800GBASE-LR1 Permutation function

In support of comment #156

Leon Bruckman, Nvidia

Figure 184–3—Lane permutation

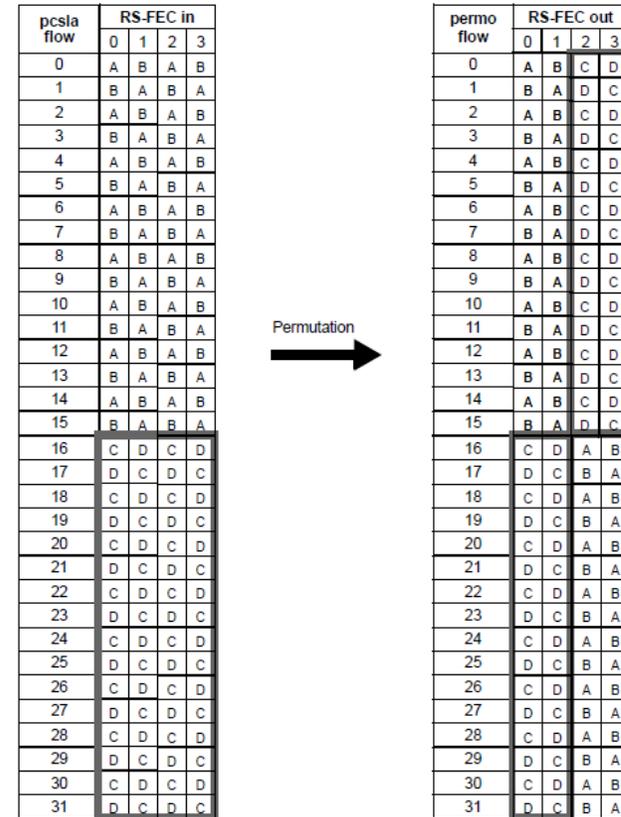
- Figure 184-3 implies that the odd/even PCS lanes are assigned to odd/even $pcsla$ flows
- It also implies that the PCS lanes 0-15 are assigned to $pcsla$ flows 0-15 and the PCS lanes 16-31 to $pcsla$ flows 16-31
- This contradicts the lane grouping definition

Either delete Figure 184-3 and the reference to it, or replace Figure 184-3 and change the text in 184.4.3 as follows:

The lane permutation function shall rearrange the RS-FEC symbols of the pcsla[q, i] Inner FEC flows to create 32 output flows such that each group of four consecutive symbols on each output flow contains one symbol from each of the four RS-FEC encoders in the 800GBASE-R PCS. **Figure 184–3 shows an example of the lane permutation function operation.**

Figure 184-3—Lane permutation

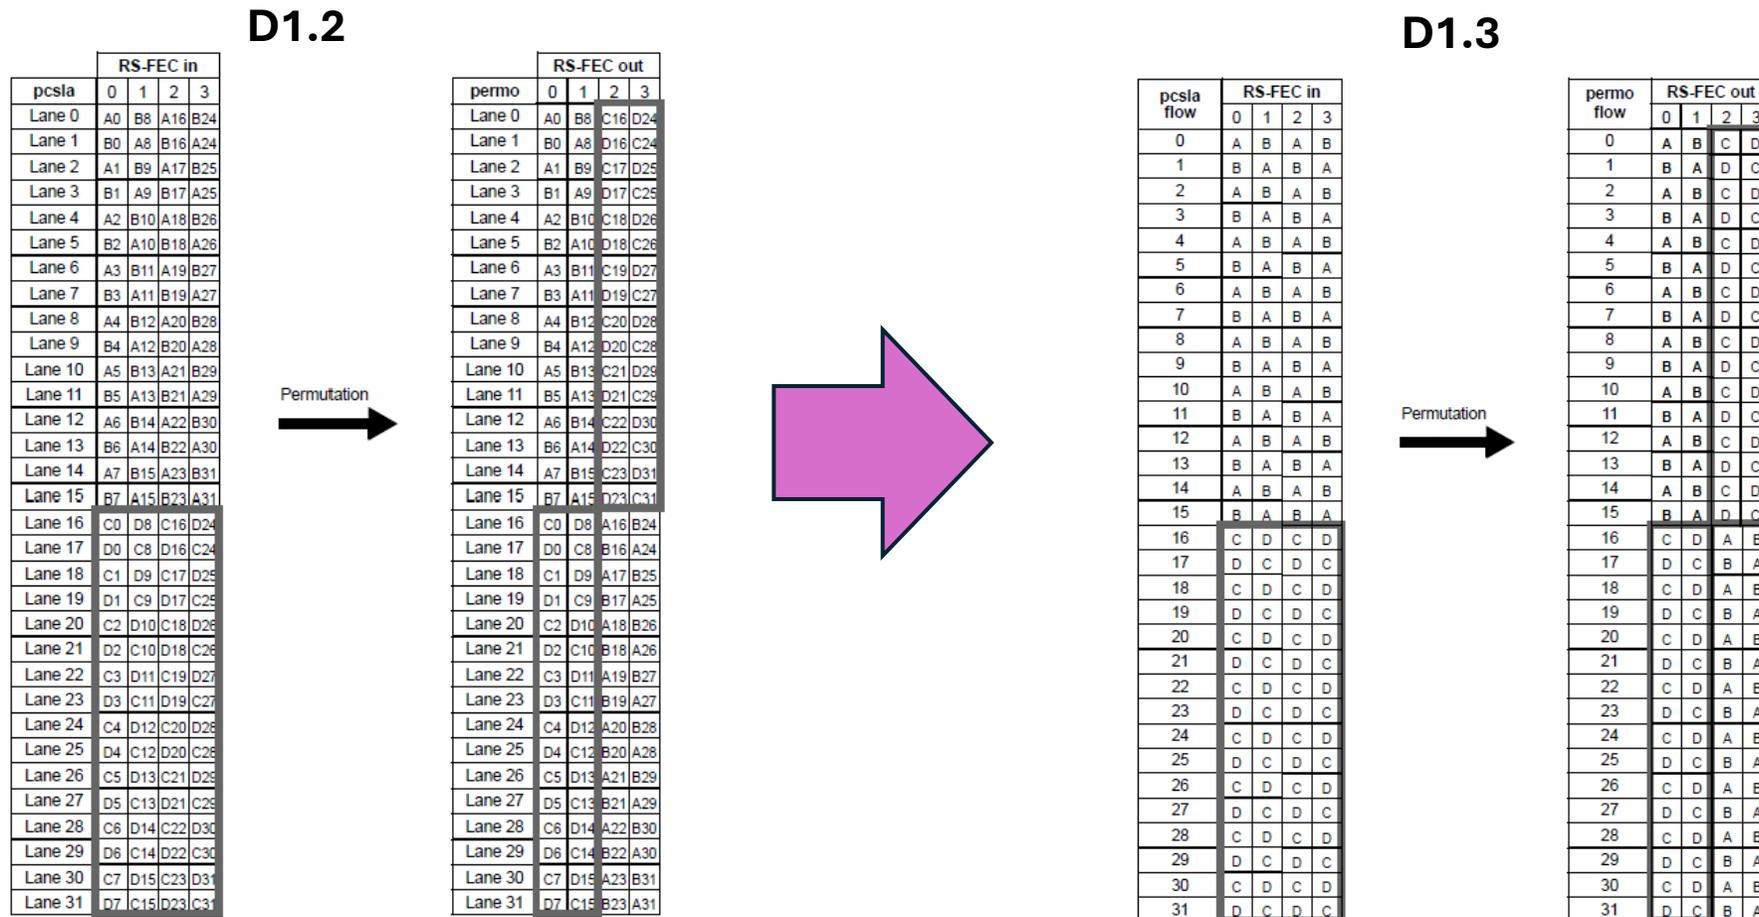
Figure 184-3 change from D1.2 to D1.3

- As part of the resolution of comment #422 against D1.2, Figure 184-3 was changed to make it more general.
